TO: Ann Arbor Public Art Commission

SUBJECT: EXECUTIVE REPORT ON JOSHUA WIENER'S DESIGN FOR PUBLIC ART AT THE KINGSLEY AND FIRST RAIN GARDEN

SELECTION PANEL'S RECOMMENDATION AND REVIEW OF DESIGN:

Overhead view of design within the rain garden layout.

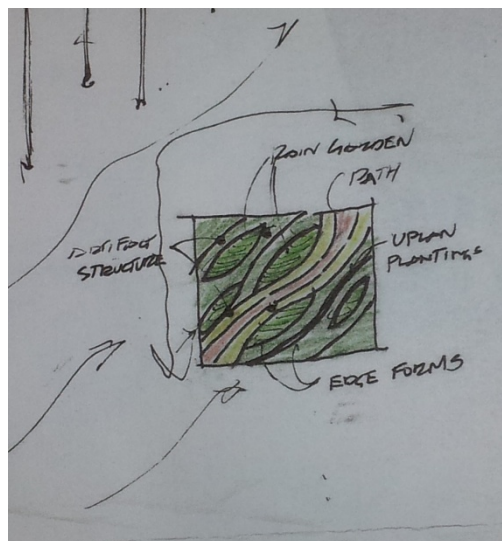
The fish are pointed toward the river. This was viewed as a matter of intent for the artist to decide, however they were thought to be pointed in an unnatural direction. It was thought fish would typically swim the opposite direction. Panel did agree that pointing the fish to the river could be a philosophical statement regarding the environmental connection to the river.

Panel agreed on the white color application. Although, it was dependent upon how it would affect the budget and if it would mean scaling back the number of sculptures. Panel did not favor a brown color.

If seating is intended upon the sculpture, there was agreement that the sculpture should not be unpainted.

Suggestion was made to have an odd number of sculptures.

Small signage could be created and installed near the seating area, or etching could be applied to the fish to create sign/messaging.

Will the low lying sculptures be covered by vegetation?

- Plan for removing graffiti
- Proof that the sculpture will remain secure and be permanent
- Is the sculpture resistant to rust and how does the paint/coating affect rust?
